Project: TriMet/Center St.

Subject: Flagpole Base

Permit Revision Application and Submittal Requirements

Description of revision Enlarge size of foundation to match new pole.

Subject: Flagpole Base By: _____ Sheet: _____

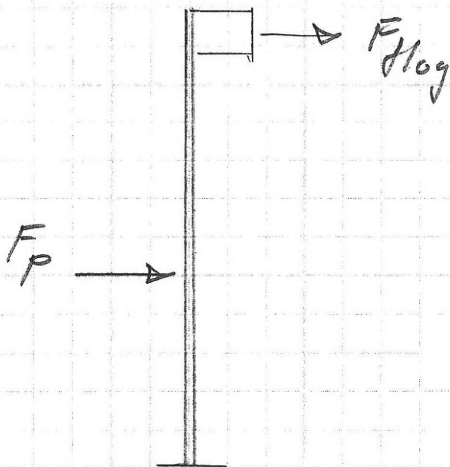
Pole Hgt = 50' - Revise to 40'

This is equiv. to $P = 1740$ @ 25' → change to 20'

use 4' ϕ x 6.0' deep.
